DESIGN REVIEW COMMISSION MEETING
“VIRTUAL”
THURSDAY, MAY 27, 2021
12:00 pm

**DESIGN REVIEW COMMISSION
STAFF REPORT**

FROM: TAMI STROUD, ASSOCIATE PLANNER
DATE: MAY 27, 2021
SUBJECT: DR-3-21: REQUEST FOR THE FIRST MEETING WITH THE DESIGN REVIEW COMMISSION FOR FIVE (5) SINGLE FAMILY RESIDENCES (COMPRISED OF FOUR TOWNHOUSES AND ONE SINGLE-FAMILY DETACHED RESIDENCE)

LOCATION: 810 E. LAKESIDE AVENUE: SOUTH SIDE OF LAKESIDE AVENUE, E. OF 8TH STREET

DESIGN DEPARTURE REQUEST

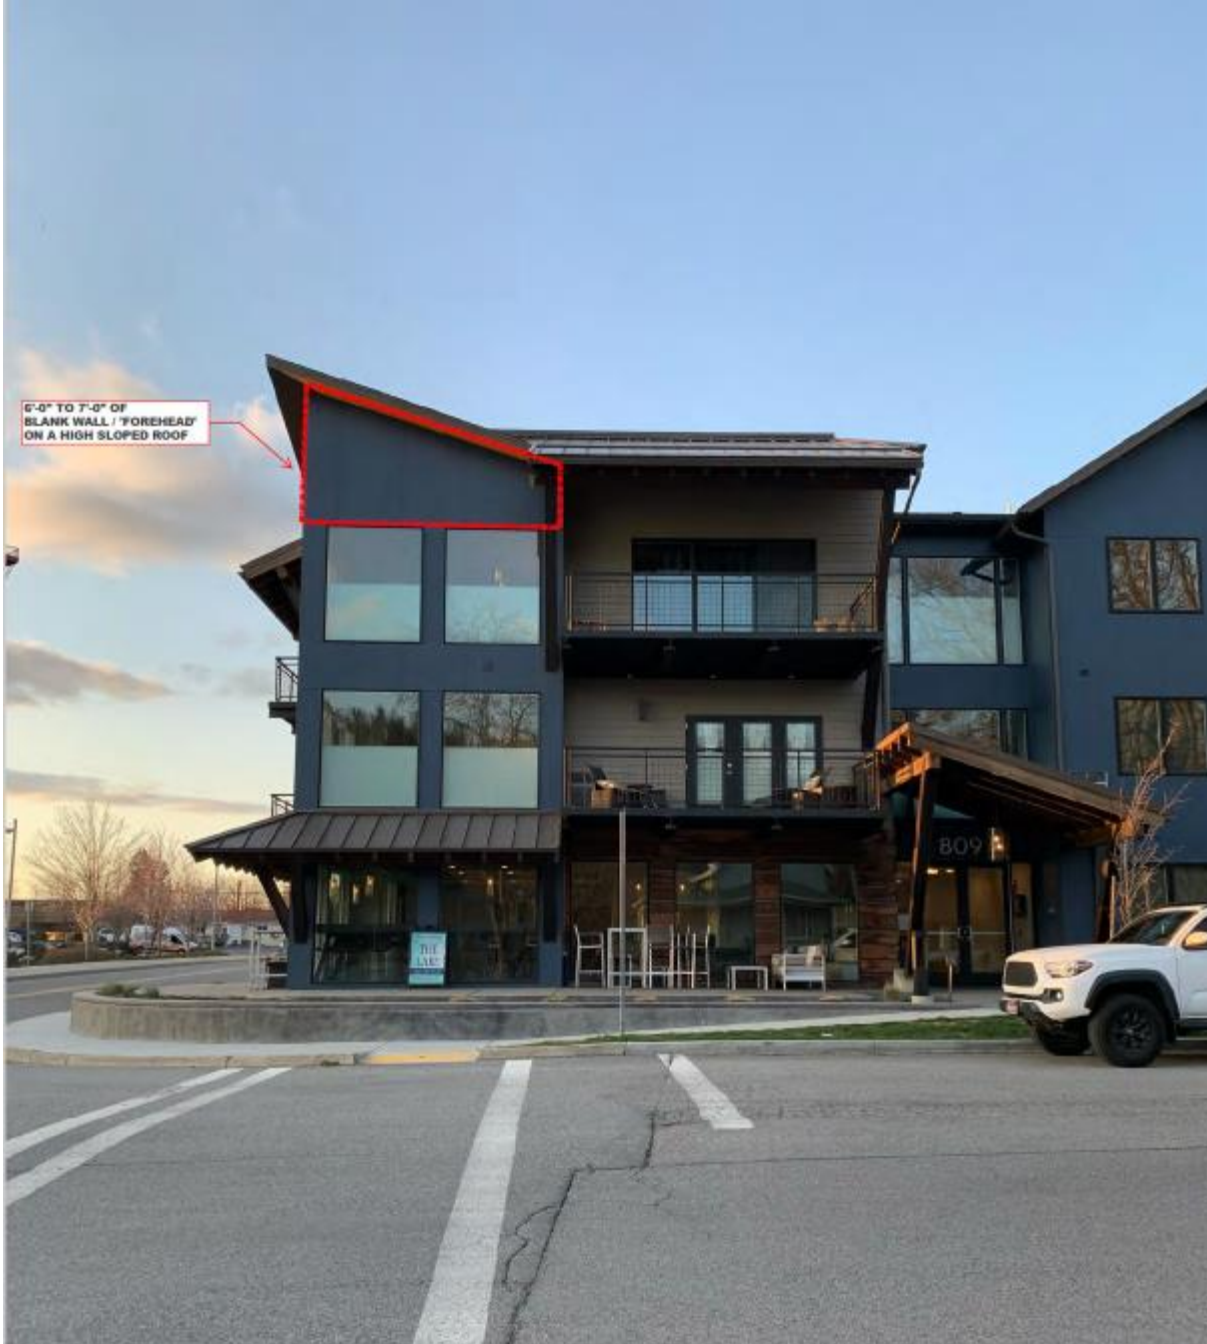
The applicant has requested a Design Departure for the Design Guideline requiring a minimum slope of 4:12 pitch and has requested the approval of a proposed 1:12 pitch for the 5-single family dwellings (comprised of four townhomes and one single-family detached residence).

The applicant has provided examples of nearby properties with a 4:12 roof pitch and states in the narrative how a 4:12 pitch would have a negative effect on their proposed project, and by having a 1:12 pitch it would reduce the potential scale of the building and meet the scale of surrounding architecture. Reducing the slope of the roof also removes 4'-0" to 5'-0" of "forehead" or blank wall space that would exist above the window line, as shown on the examples on the following pages. The maximum height limit of 35' is allowed in the DO-E. There are also examples of homes in the vicinity with less than a 4:12 pitch. (See applicant's design departure request below.)

Section 17.07.940 of the Design Guidelines state that the guidelines allow for some flexibility in application, providing that the intent of the Code is met. The Applicant has requested the above-noted Design Departure. In order for the DRC to approve a design departure, they must find that:

We believe that, in this particular situation, a 4:12 roof pitch would not only be detrimental to the project and its aesthetics - but would also have a negative effect on surrounding neighborhood. In an effort to reduce the potential scale of the building and bring it back down to meet the scale of the surrounding architecture, we have designed the standing seam metal roof to have a 1:12 pitch. By simply lowering the pitch from 4:12 to 1:12, we are effectively eliminating between 4'-0" and 5'-0" of building height.

By reducing the slope of the roof, we are also removing 4'-0" to 5'-0" of "forehead" or blank wall space that would exist above the window line (see attached examples). By eliminating this forehead, we are allowing the roof line and exposed heavy timber rafters to float just above the windows instead of 4'-0" or 5'-0" above empty space.

Hilary Anderson, Community Planning Director, has recommended approval of the requested Design Departure as listed above. The Design Review Commission will make the final determination on the design departure and the overall project design. The applicant's Narrative provides additional information.
